Memorandum

To:	Claire Pascoe, Renee Corlett	Of:	Wellington City Council
From:	Lukas Adam	Date:	5 October 2022
Copies:	Bridget Doran		
Project:	NZ3257		
Subject:	Riddiford Street bus stop bypasses - accessibility audit

Figure 1: Bus stop bypass design - 30% concept design (October 2021)

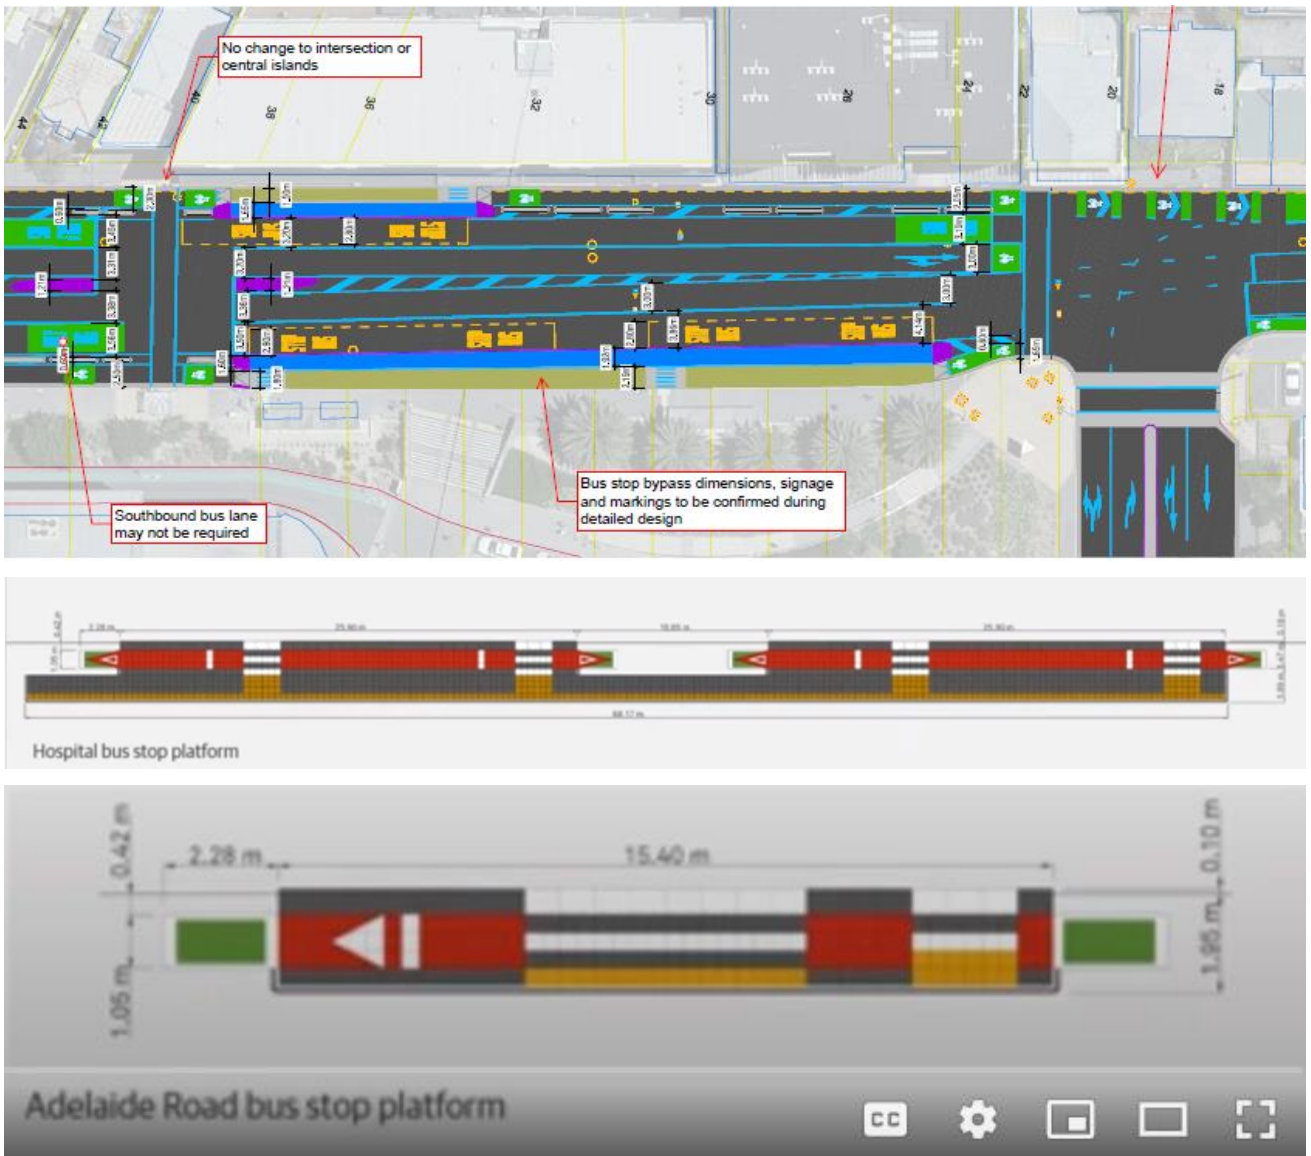
The designs are shown in **Figure 1** and site photos are included in Figure 2. Note that we have not confirmed dimensions on-site. We have assumed that dimensions shown on drawings are the same as what has been constructed.

Figure 3: Bus stop bypass terminology

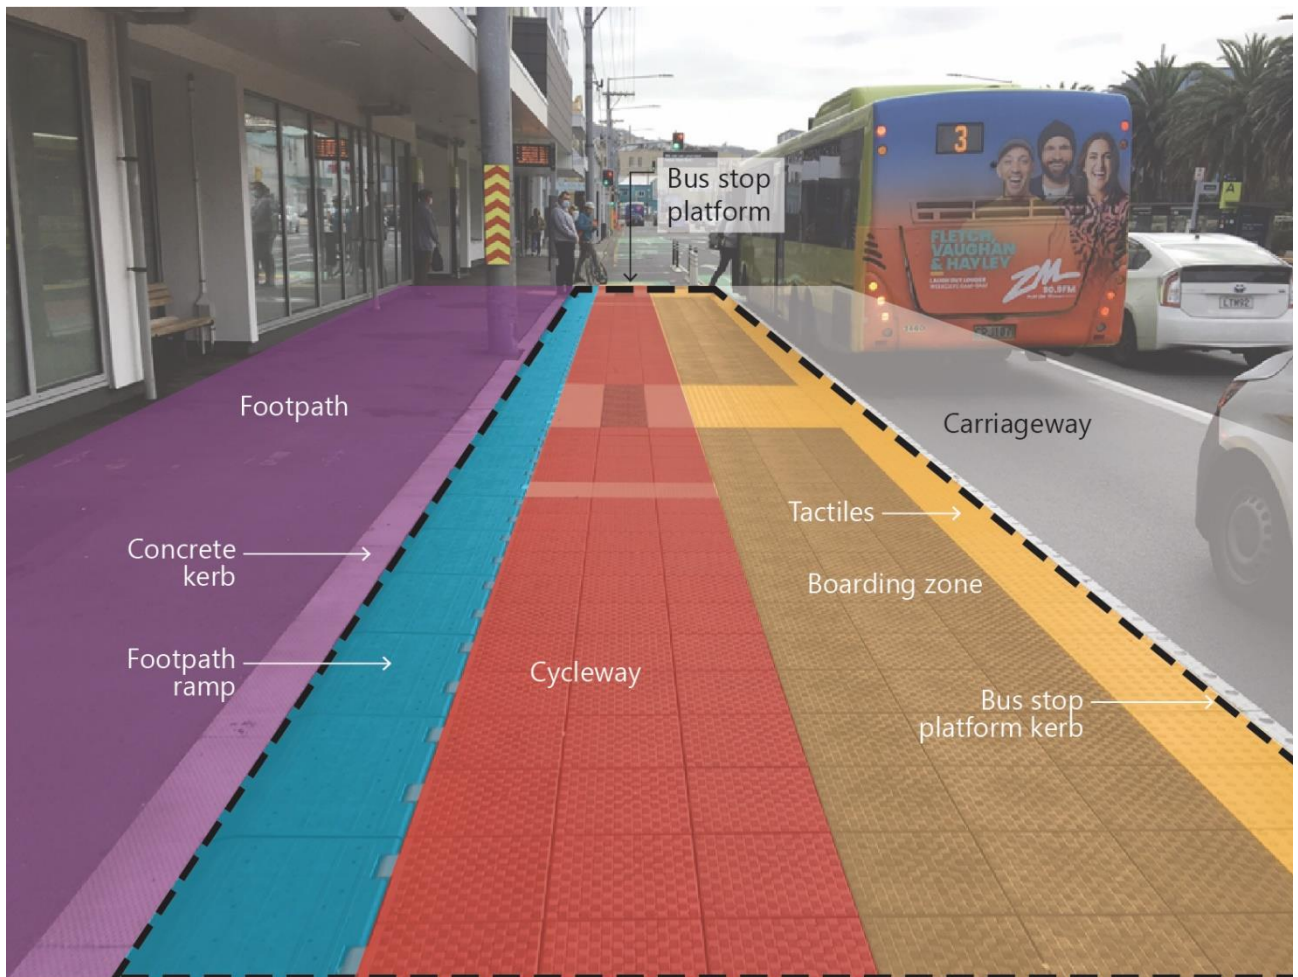
Figure 3 sets out the terminology used in this document regarding bus stop bypass elements.
